SITE INSTRUCTION

PROJECT: HAMPTON MANOR
25 BAKER HILL BLVD
STOUFFVILLE, ONTARIO

SITE INSTRUCTION: E-10

Purpose: To coordinate with the Interior designer and architectural drawings, site conditions and for clarifications.

TITLE GROUND FLOOR PLAN - A ELECTRICAL			
PROJECT PROPOSED RESIDENTIAL DEVELOPMENT 25 BAKER HILL BLVD.			
DRAWN CM			
CHECKED MG			
SCALE 1:75			
DATE SEPT. 2015			
PROJECT 14-016			
DRAWING E-3A			
OF 12

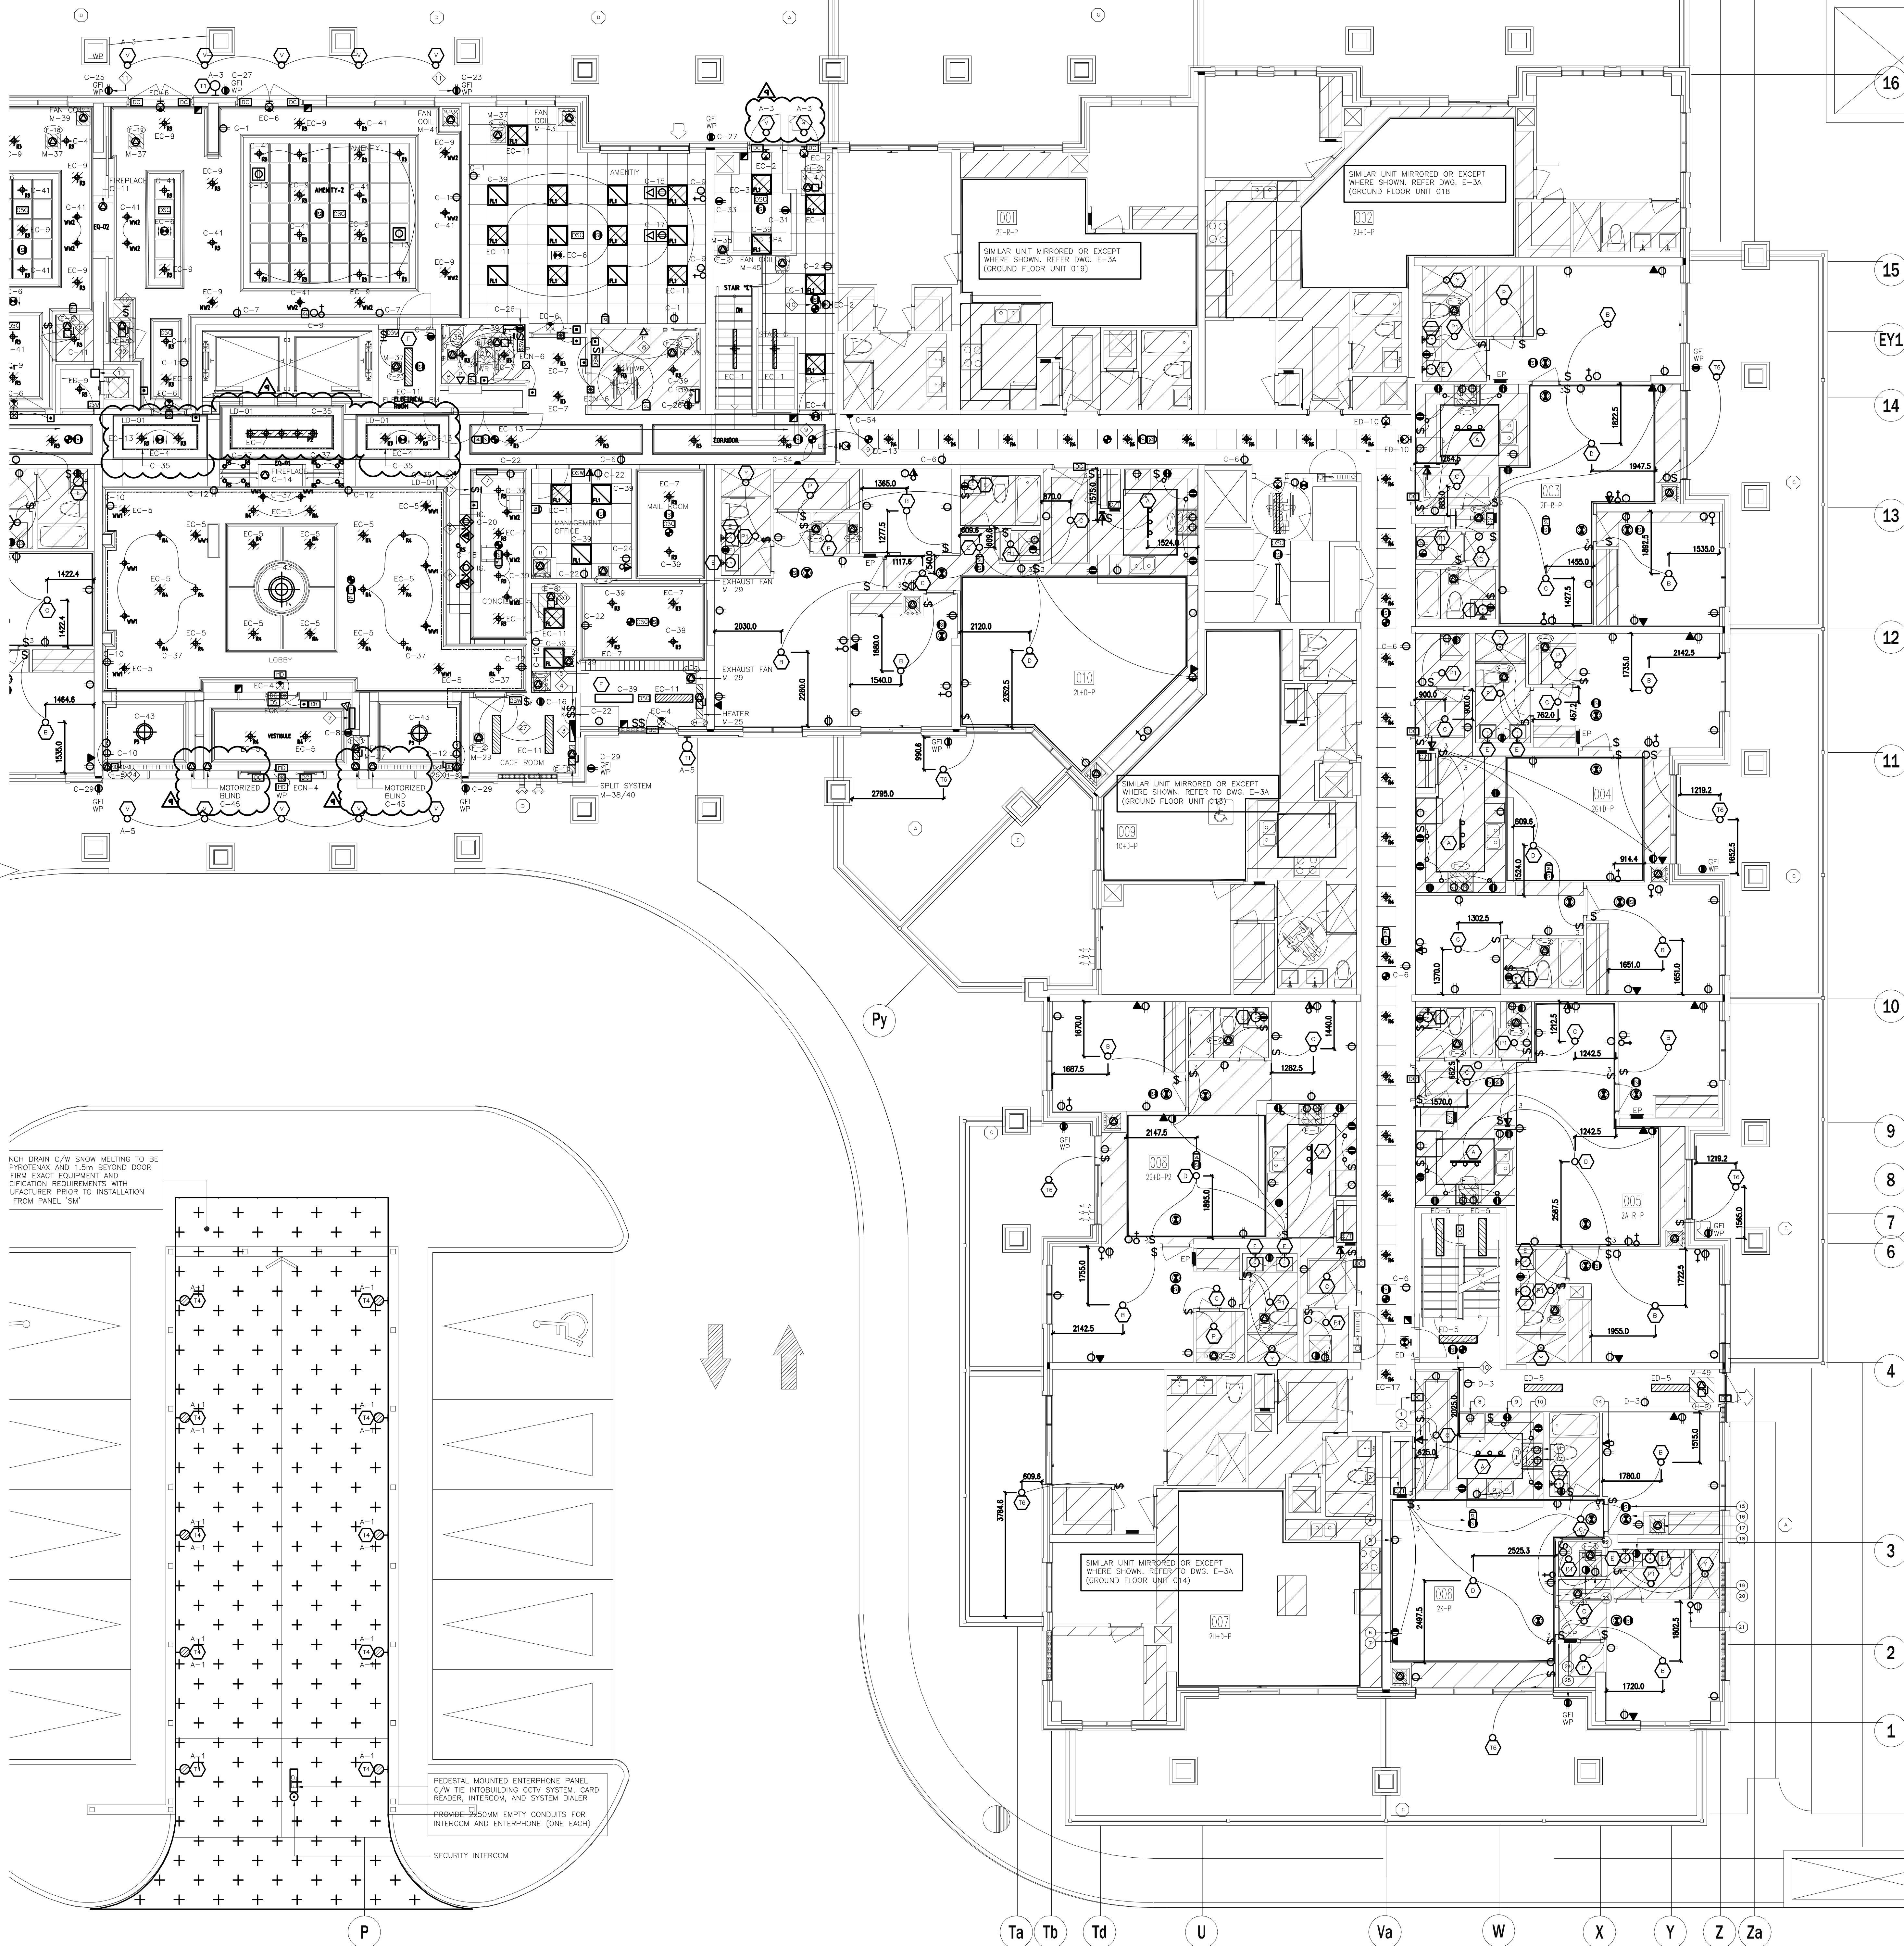
2.0 Reference Drawing E-3A (Ground Floor Plan - A) Issued

- 2.1 Add: One (1) type V lighting fixture at south exit door.
- 2.2 Clarify: Exterior lighting to be type V lighting fixture outside amenity area.
- 2.3 Add: Exterior lighting type V lighting fixture outside amenity area.
- 2.4 Revise: Exterior lighting to be type V lighting fixture outside amenity area.
- 2.5 Add: LD-01 cove lighting at lobby corridor.
- 2.6 Add: Power connection for motorized blinds at front facade entry two storeys.

DRAWN CM	CHECKED MG	SCALE 1:75
DATE SEPT. 2015	PROJECT 14-016	DRAWING E-6A
		OF 12

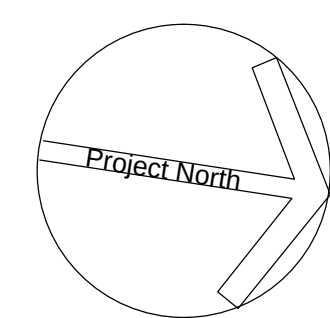
6.0 Reference Drawing E-6A (6th Floor Plan – A) Issued

- 6.1 Relocate: One (1) receptacle on balcony.
- 6.2 Add: One (1) receptacle on balcony.

DRAWN	CM	CHECKED	MG	SCALE	1:75
DATE	SEPT. 2015	PROJECT	14-016	DRAWING	E-6B
				OF	12

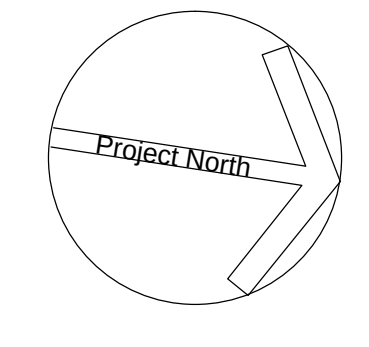
7.0 Reference Drawing E-6B (6th Floor Plan – B) Issued

- 7.1 Relocate: One (1) receptacle on balcony.

DRAWN	CHECKED	SCALE
CM	MG	1:75
DATE	PROJECT	DRAWING
SEPT. 2015	14-016	E-7A
		OF 12

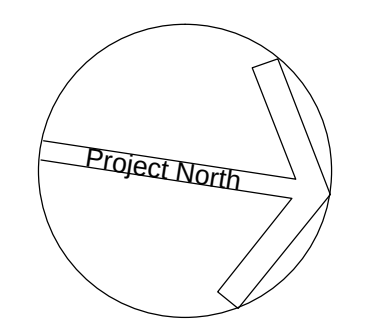
8.0 Reference Drawing E-7A (7th Floor Plan – A) Issued

- 8.1 Relocate: Two (2) exterior balcony receptacles and one (1) wall mounted type T6 lighting fixture.
- 8.2 Delete: Two (2) exterior balcony receptacles.
